CITY OF BELLE ISLE PLANNING AND ZONING BOARD REGULAR SESSION

ITEM 3 MEMORANDUM

Public Hearing Case #2017-07- 023 - Proposed Development Site Plan. Pursuant to Belle Isle Code Sec. 54-79 (f) (4), the Board shall review and take action on the proposed site plan, submitted by Thirumala Property's, LLC c/o American Civil Engineering, Co. for a proposed commercial development at 2635 McCoy Road, Belle Isle FL 32809, also known as Parcel #30-23- 30-0000- 00-005. (Continued from the August 22, 2017 meeting)

Site Plan Review: 2635 McCoy Road

SECTIONS
project no. 15325
sheet number
6 of 9

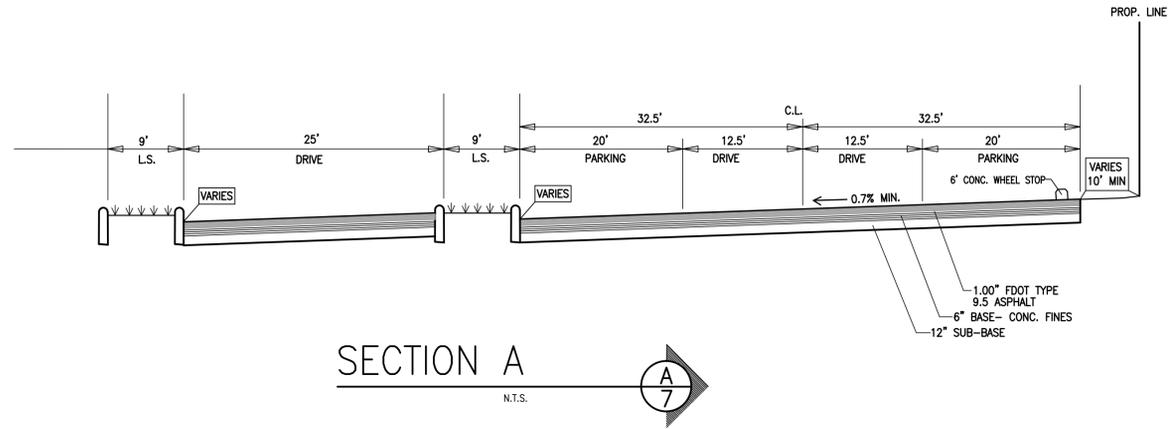
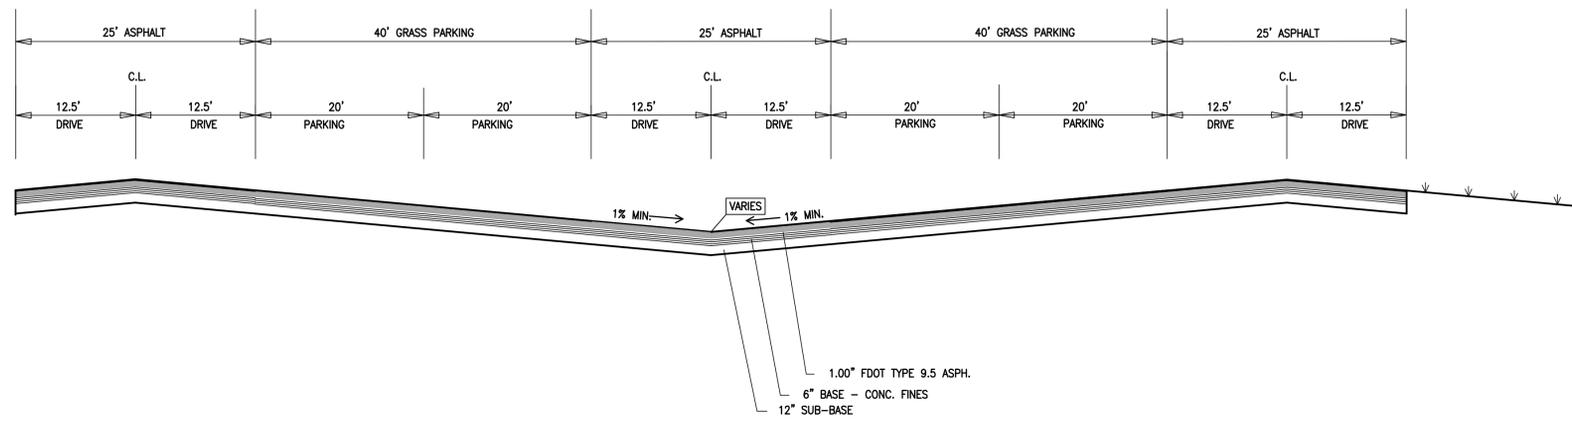
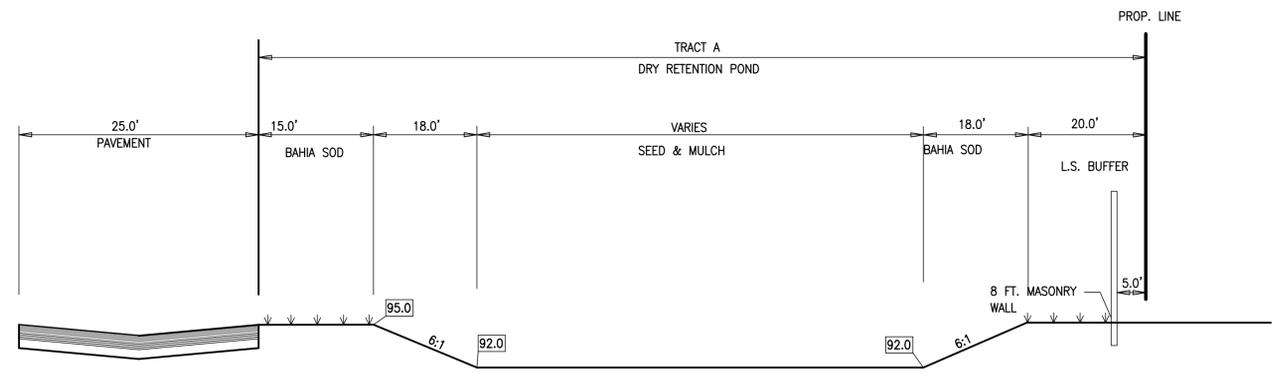
1. The applicant indicates that they have removed the proposed grass parking, however, Sheet 6 of 9 contradicts this and must be revised or a variance would be required.

7. Grass parking is not allowed in a commercial development.
The grass parking has been replaced by pavement and the ISR has been revised on plan sheet 3.
